Access Compliance Report

Public Rights-of-Way

(Pedestrian Signals)

Intersection ID: N/A	Main Street:	Cross Street: N/A	Location: N/A
ADA ID: 78E745A12299	Signal Type: Two Push Buttons-Non APS	Overall Compliance: No	Severity Score: BTN 1:N/A BTN 2: N/A No BTN: N/A
Codes/Mitigation Info/Possible Solution		Field Measurements/Component Compliance

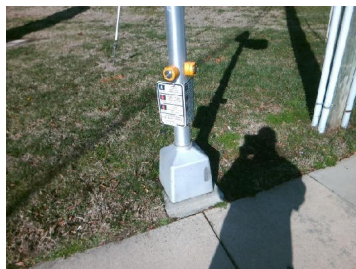
Possible Solutions: Provide Push Button Extension. Remove and Replace Clear Space.

PROW/ADA: R404.2, R404.3, R406.2
